Subject: **THIRD RESPONSE TO PEER REVIEW**
Phase 2 of Tentative Tract 37-46
White Mountain Estates Subdivision
Chalfant Valley, Mono County, California

Reference: Review of Revised Site Geologic Map
Phase 2 of Tentative Tract Map No. 37-46
White Mountain Estates Subdivision
Chalfant Valley, Mono County, California
Prepared by AMEC Earth & Environmental dated June 13, 2006

PROJECT: GEOLOGIC LOG OF TRENCH T-12 PHASE 2 OF WHITE MOUNTAIN ESTATES SUBDIVISION				
HORIZ. SCALE: 1"=5'	VERT. SCALE: 1"=5'	DATE: 8/16/2006		
DRAWING: 3.30559_TRENCHES.DWG	LOGGED BY: HDD/RWS	DRAFTED BY: HDD/RWS		
JOB NO.:	3.30559	TITLE: SHEET 4 OF 6

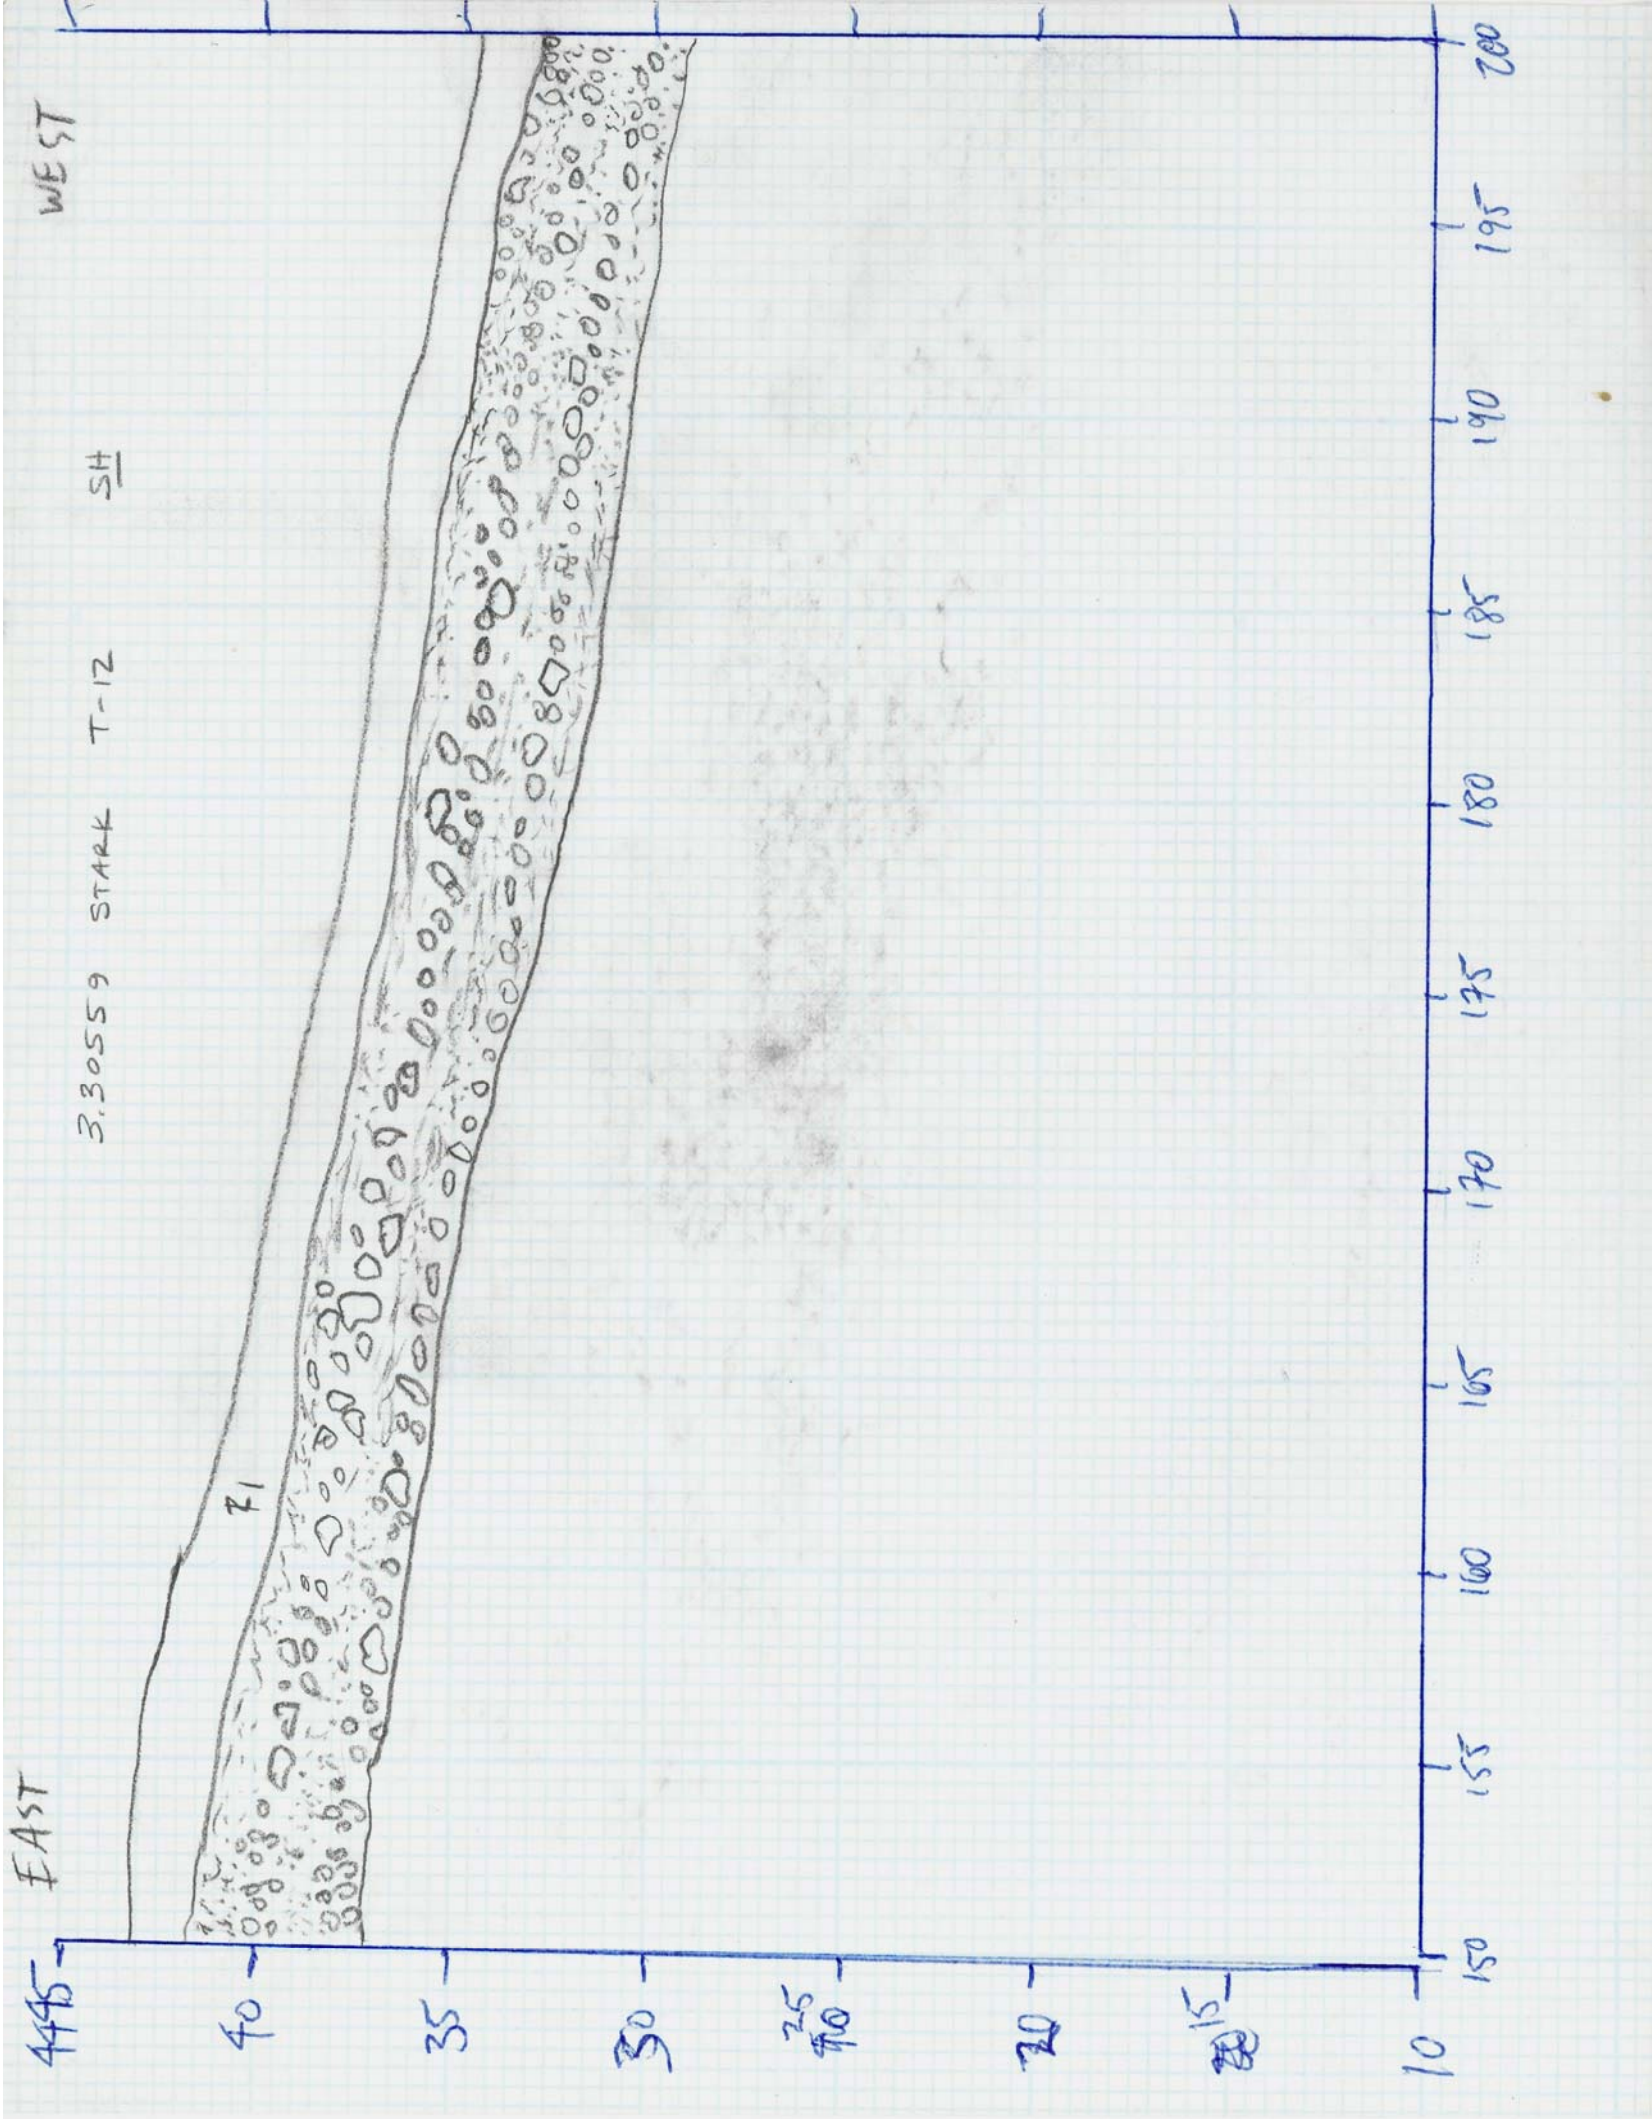
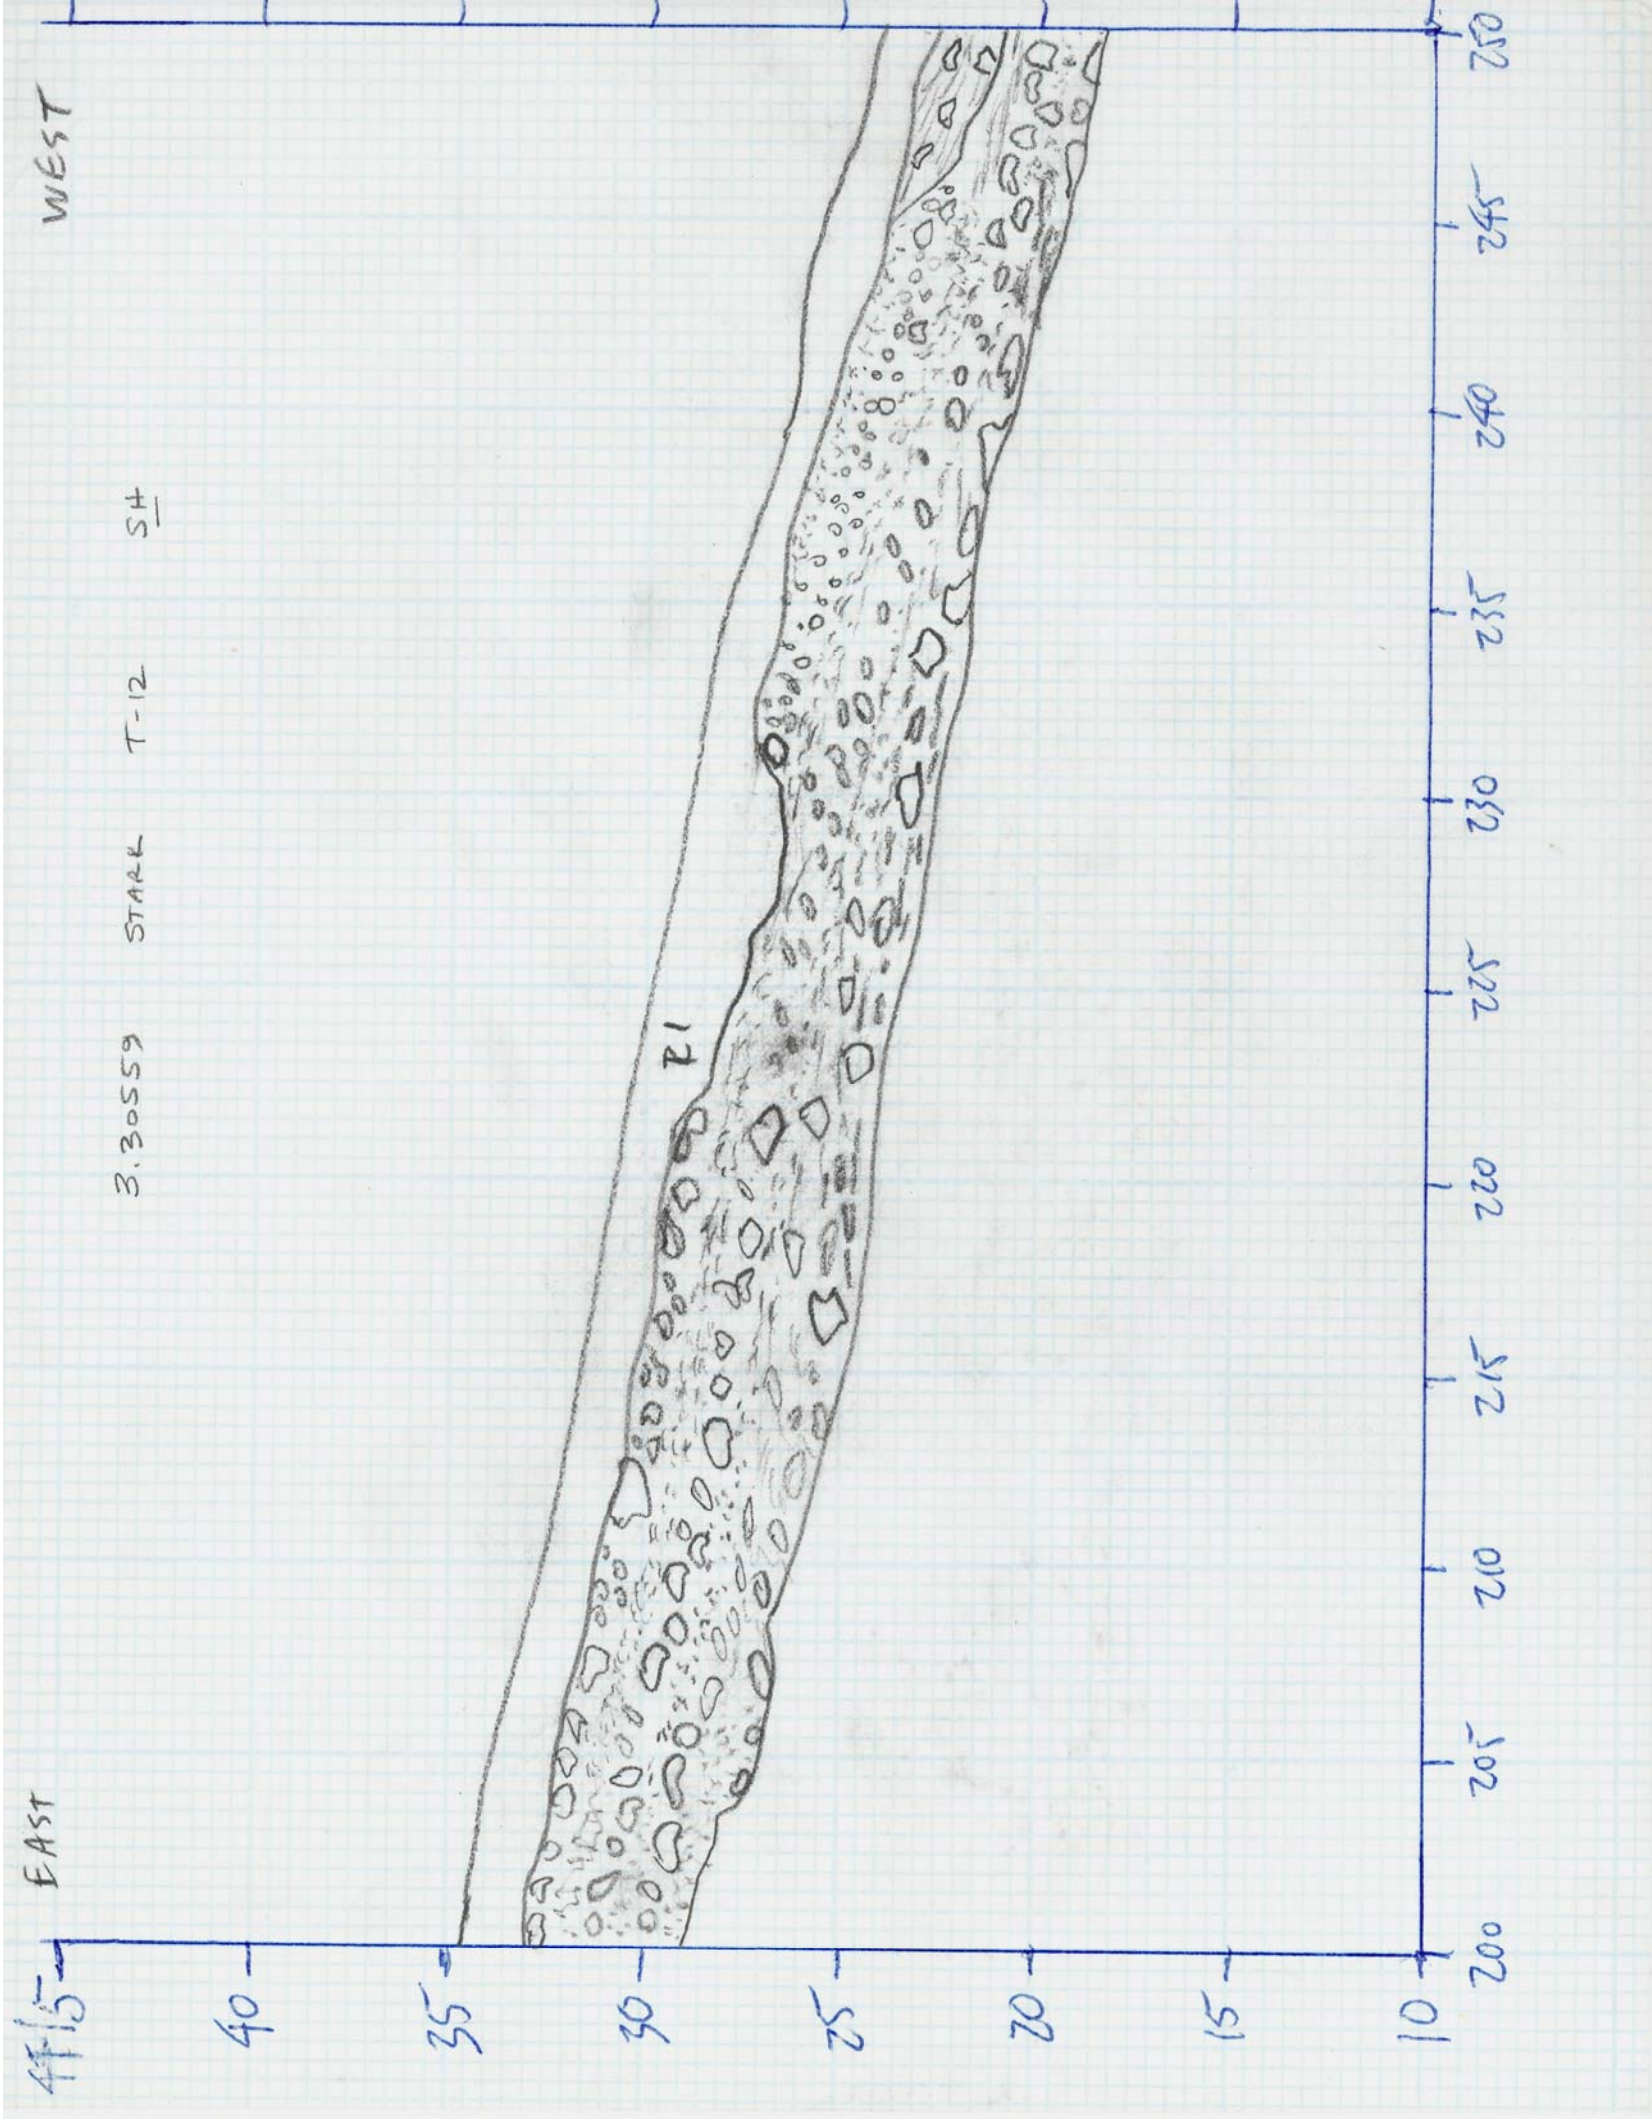
Due to the uncertainty associated with the location or projection of active fault features from the existing exploratory fault trenches it is recommended that Minimum building areas be established for each lot within the existing habitable zones. Building areas that can be established immediately adjacent the existing fault trench excavations are approved with respect to active faulting based on the existing data. Proposed building areas that are more than 50 feet from an existing fault trench will require additional subsurface fault trenching to establish that the building area is free of active faulting. The location of any proposed additional fault trenches, to substantiate the validity of a proposed building area, should be reviewed and approved by the geotechnical consultant for Mono County prior to excavation and logging. The designation of acceptable building areas, verified by the existing fault trench data or new fault data as discussed above, should be accomplished prior to Mono County's approval of the tract.

Response: Two additional fault trenches were proposed and located upon approval via telephone and email from the geotechnical consultant (AMEC) for Mono County. Each trench was located to provide additional data within those habitable areas that had been previously established by rather lengthy projections. Additional Fault Trench T-11 was excavated and logged across the habitable zone that traverses proposed Lot 43, and additional Fault Trench T-12 was excavated and logged across the habitable zone that traverses proposed Lot 41. Each trench exposed faulting OUTSIDE of each habitable

zone as was anticipated from our previous findings. Faulting was NOT observed within either habitable zone on either lot. Therefore, we have revised each habitable zone to reflect these findings, and they are shown on the attached Revised Site Geologic Map. Based on the dimensions of the largest footprint of the manufactured homes that are proposed for the subject site, Minimum Building Areas (MBA) have also been established for each lot within each revised habitable zone. It should be noted that each MBA location is provided to demonstrate fit and buildability within the habitable zone only; they are not intended to restrict structures to that location or dimension. The west side of the habitable zone across Lots 40 and 42 has been revised such it is now setback fifty feet from the nearest mapped fault to the west, and as a result the MBA on Lot 42 has been repositioned inside the habitable zone such that there is still adequate room for a habitable structure. Additionally, the habitable zone has been removed from proposed Lot B Common Area for Phase 1 of Tentative Tract 37-46 since the proposed water storage tank and propane tanks are not habitable structures; however, their proposed locations have been plotted such that they are as far away as possible from the nearest mapped faulting on this lot in order to minimize the potential for disruption or damage to the tanks from future ground surface rupture-causing events.
